**RE: Rancho Cordova Homewood Suites (DD9678)**

WALKSacramento would like to provide comments on Homewood Suites (DD9678) with the goal of improving the walkability of the proposed project. The Homewood Suites project proposes to construct a 105-unit 4-story hotel with pool, basketball court and 142 parking spaces at the southeast corner of White Rock Road and Quality Drive. The site is within 10-minute walking distances of two shopping centers, about 20 multi-story office buildings, 7 hotels, Rancho Cordova City Hall and stops for 3 bus routes. Many of the streets in the area have low- to moderate-traffic volumes and speeds with substantial tree canopy behind 6'-wide sidewalks which can provide for a pleasant walking and biking experience. Homewood Suites can take advantage of this environment to provide a "home base" for their guests that's walkable and encourages walking with some changes to the proposed site and architectural designs.

Figure 1 Additional access to main entrance

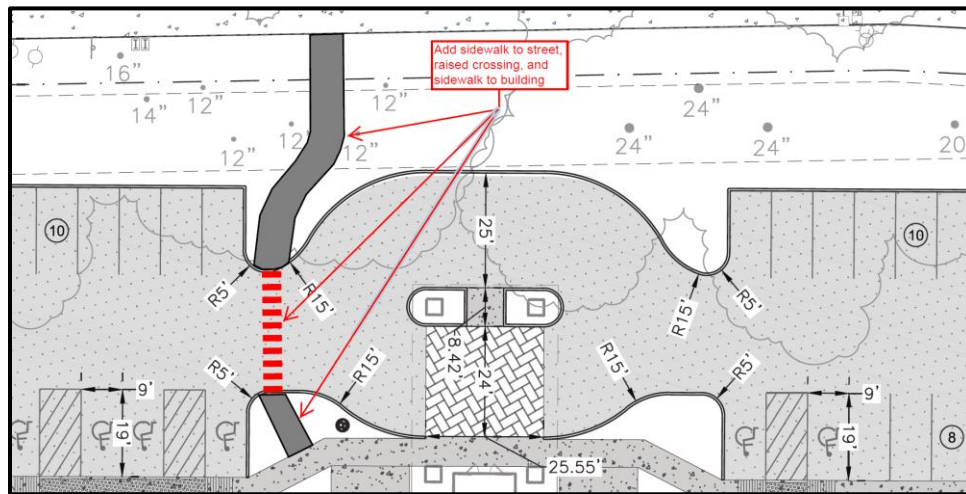
The project description states “The main entry is inviting, open, engaging and clearly defined to pedestrians passing through.” The 6’ high shrubs and Japanese Maples that about the street side of the drive aisle at the main entry will significantly diminish the visibility from the sidewalk along White Rock Road. However, even if pedestrians have a clear view of the entrance, the site design doesn’t offer easy access. **WALKS** recommends adding walkways and a raised driveway crossing between White Rock Road and the building’s main entrance. See Figure 1. A raised crossing rather than a marked crosswalk is preferable because it should discourage temporary parking on the crossing by guests while they check in.

Figure 2 Revised sidewalk at northeast corner of site

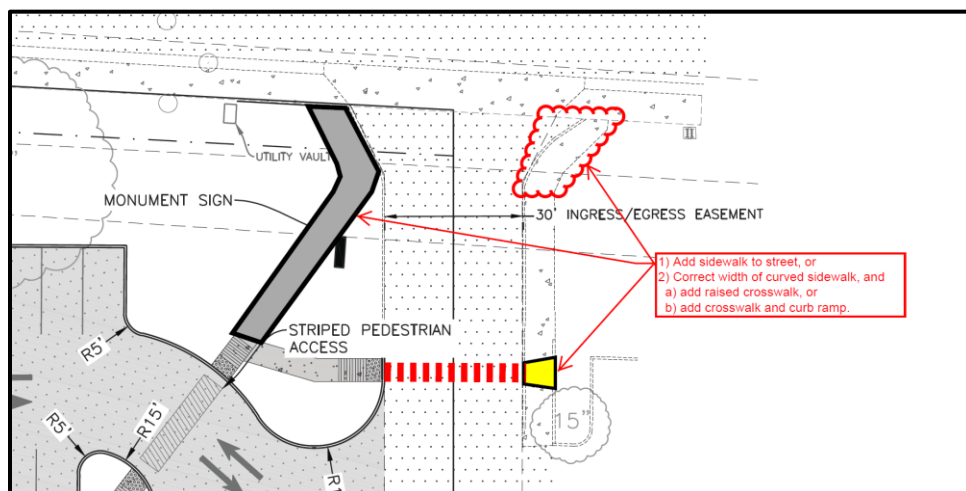
There is a pedestrian walkway provided from the northeast corner of the building to the White Rock Road shared driveway. It appears this design will require construction of a curb ramp on the adjoining property, and the curved section of sidewalk that attaches to the public sidewalk narrows as it approaches the street. **WALKSacramento recommends continuing the walkway from the northeast corner of the building by extending the sidewalk to White Rock Road entirely on the west side of the driveway.** This would eliminate the need to provide the crosswalk and curb ramps on both sides of the driveway. See Figure 2.

*Figure 3 Revised pedestrian access from Quality Drive*

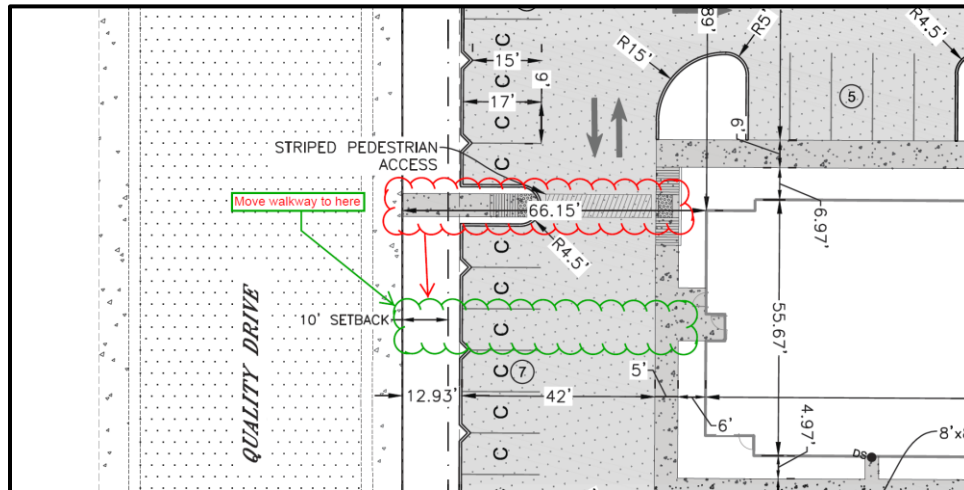
Access between Quality Drive and building entrances is not direct; it requires either several turns to get to the west door, or walking around the corner of the building and down the sidewalk to get to the main entrance. **WALKSacramento recommends moving the sidewalk and striped pedestrian access between Quality Drive and the building so that it directly approaches the west entrance door.** See Figure 3.

*Figure 4 Additional sidewalk on south side of building*

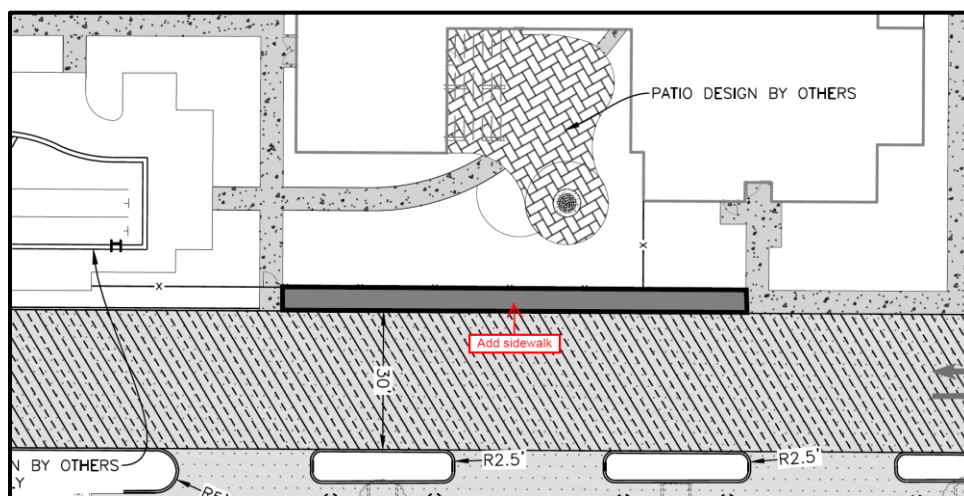
There's no continuous walkway along the south side of the building; adding a section of sidewalk between the pool-area and south-door sidewalks would provide more complete and safer pedestrian circulation. **WALKSacramento recommends adding a sidewalk between the pool area and the door near the southeast corner of the building.** See Figure 4.
